NATIONAL ACADEMY OF SCIENCES

LETTER REPORT OF MAY 1, 1979

COMMITTEE ON RADIOACTIVE WASTE MANAGEMENT

REVIEW OF THE CRITERIA FOR THE
SITE SUITABILITY, DESIGN, CONSTRUCTION, AND OPERATION
OF THE PROPOSED
WASTE ISOLATION PILOT PLANT (WIPP)
PROGRESS REPORT: JULY 1, 1978, to DECEMBER 31, 1979

FIGURE 3.1. Repository room design.
SOURCE: Bechtel National, Inc. (1979).

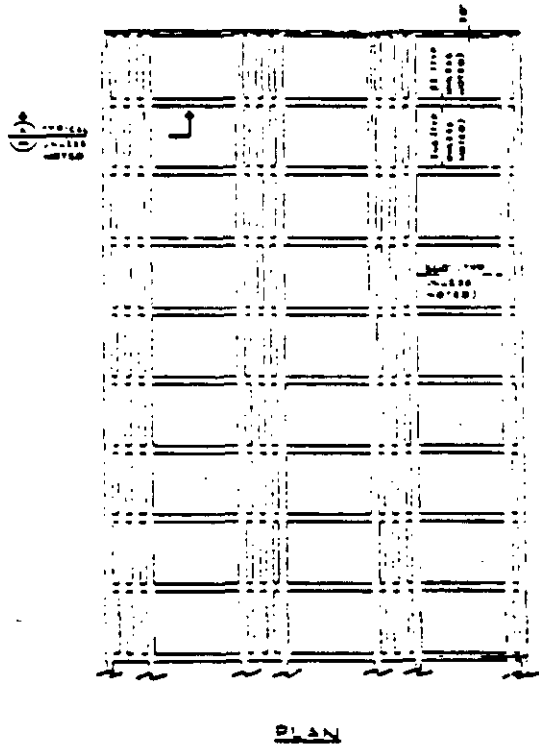
As shown in Figure 3.1, the original Title I design [note: changes in this design made since the end of 1979 should be reviewed by the Panel in its subsequent deliberations] showed the repository essentially as sets of four rooms 32 ft (9.7 m) wide, separated by support pillars 25 ft (7.6 m) wide, and separated from adjacent sets of rooms and pillars by abutment pillars 360 ft (109 m) wide, penetrated at intervals of 268 ft (81.2 m) by crosscuts. This design gives an overall extraction ratio of about 26 percent. Kaiser Engineers, Inc., note that "A room with a central pillar is not favored because high extraction ratio is counterproductive for a repository, where safety is reduced and cost increased as extraction is increased" (Watson et al. 1979).

This original Title I design incorporated a degree of modular design through the use of the large abutment pillars, but the integrity of the pillars was destroyed partially by the crosscuts. The Panel was advised that these crosscuts would be closed by bulkheads at each end and that, finally, the space between bulkheads would be sealed by filling each crosscut, in an endeavor to restore the integrity of the abutment as a whole. The original Title I drawings, however, show that these crosscuts are to be used for the disposal of waste. The isolation that would be provided by the bulkheads in the event of fire, flooding, or leakage of waste is questionable, and thus even the modest degree of modularization in the original design is compromised. The Panel is convinced that truly modular repository design would make better provision for geological variations and would provide more inherent safety, by preventing accidents or failures in one part of the repository from spreading throughout the repository.

A well-established rule of thumb from wide mining experience is that adjacent excavations should occupy less than a third of the plan area if there is to be no adverse interaction between them. Figure 3.2 was prepared by Serata (1978) of Serata Geomechanics, Inc., consultants to Bechtel on the design of the underground excavations at the WIPP facility who have a wealth of experience in evaporite mining. The figure illustrates the interaction between two adjacent circular cavities in weak and strong salt at various depths as a function of the ratio of their separation to their diameter. From this figure it is clear that this ratio must be greater than 4 to preclude excessive interaction. Serata claims that at ratios of less than unity the plastic deformation of the salt between cavities is stable, but it

would seem to be most imprudent to design a radioactive waste repository, especially an early repository, in such a way that there was any question whatsoever about the behavior and stability of the salt between the excavations.

FIGURE 6-2 Schematic representation of scenario 2. Source: U.S. Department of Energy (1980).

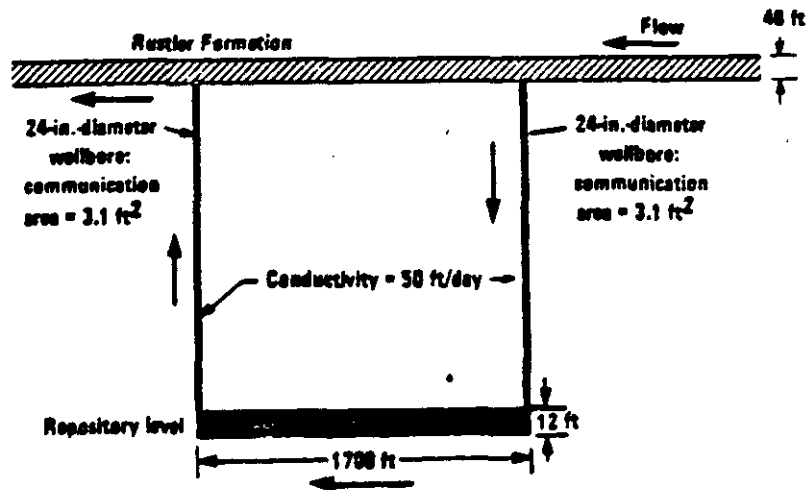
The second scenario assumes unsaturated flow through a drill pipe from the Rustler through the repository and saturated flow back to the Rustler and to Malaga Bend. The driving force for this scenario appears to be lacking, since the unsaturated water (8,000 ppm) flow does not appear to have the potential to push the saturated (400,000 ppm) flow out of the repository (see Figure 6-2).

FIGURE 6-2 Schematic representation of scenario 2. Source: U.S. Department of Energy (1980).

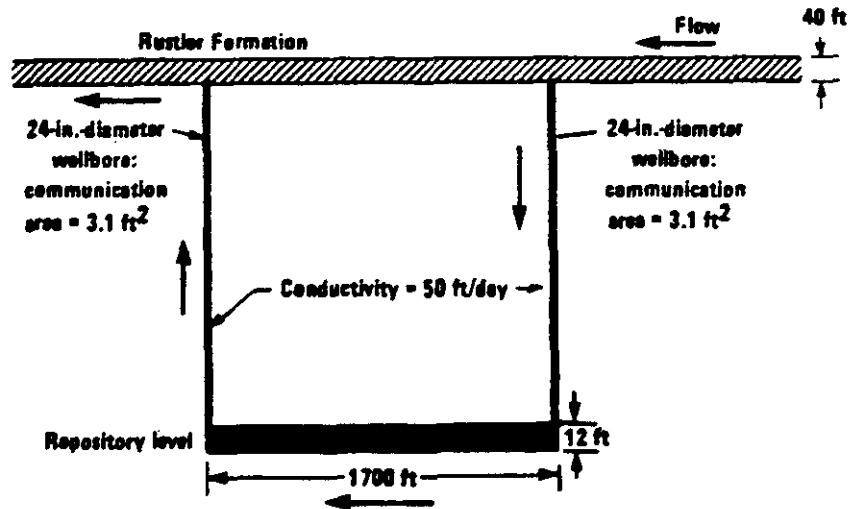
The second scenario assumes flow of dilute brine through a drill pipe from the Rustler through the repository and saturated flow back to the Rustler and to Malaga Bend. The driving force for this scenario appears to be lacking because the unsaturated water (8,000 ppm salt) flow does not appear to have the potential to push the saturated (400,000 ppm salt) flow out of the repository (see Figure 6-2).

FIG 1. Recommended Layout of Intermediate Scale Time-Dependent Deformation Test

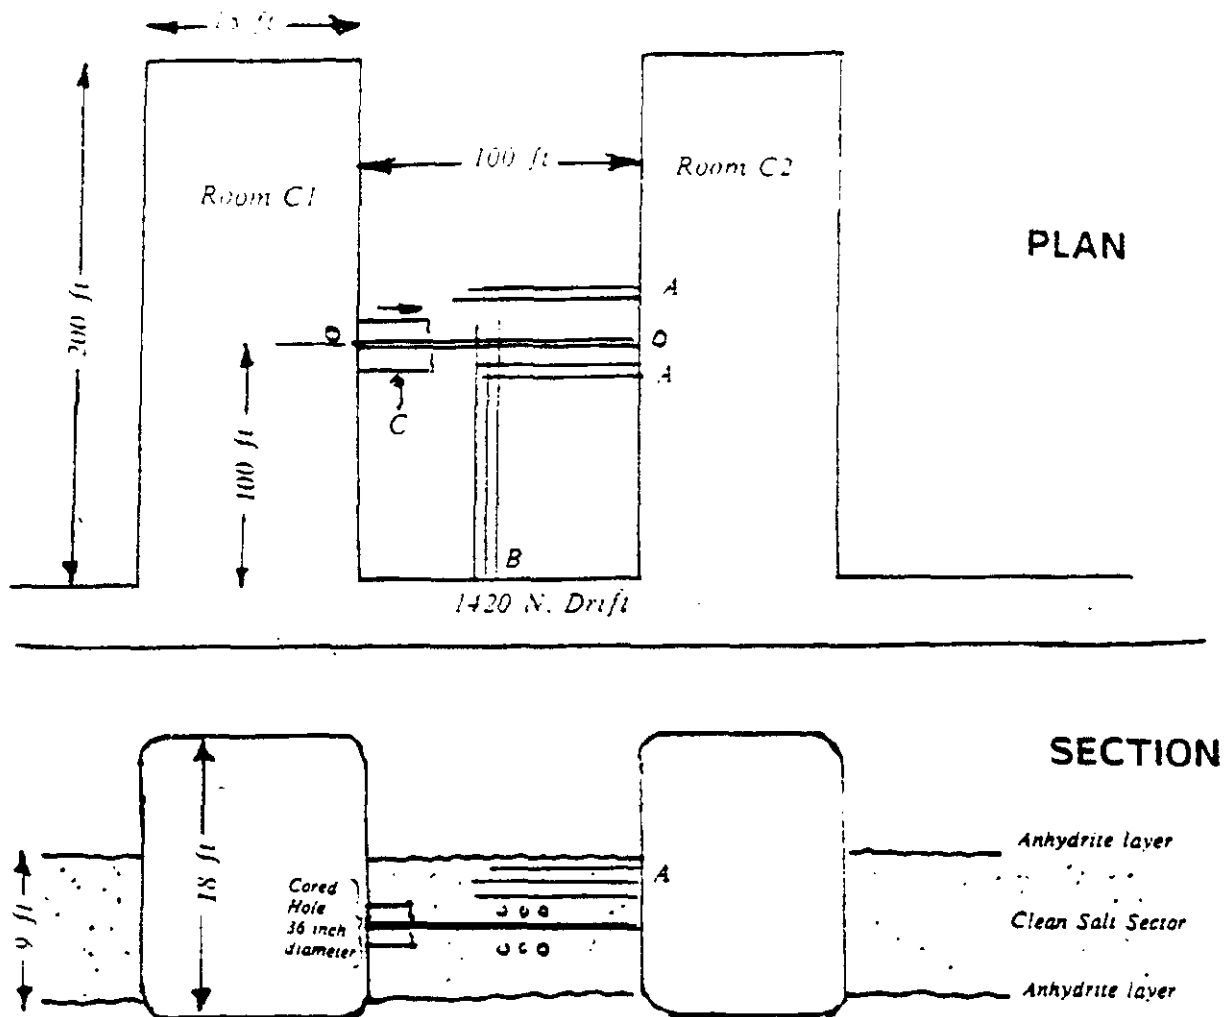
Figure 1 shows the site and test layout recommended on the basis of the discussions. In essence, a 36-in.-diameter, 100-ft.-long borehole would be drilled between two drifts in a 9-ft.-thick layer of uniform ("clean") salt at an elevation midway between two anhydrite layers. At this spacing the influence of the anhydrite layers on the deformation behavior of the borehole should be negligible. Installation of stress change and deformation gauges in the vicinity of the 36-in.-hole prior to coring should allow observation of all deformation, including the "early-time" deformation, resulting from drilling the hole. This early deformation was not observed in the full-scale tests.
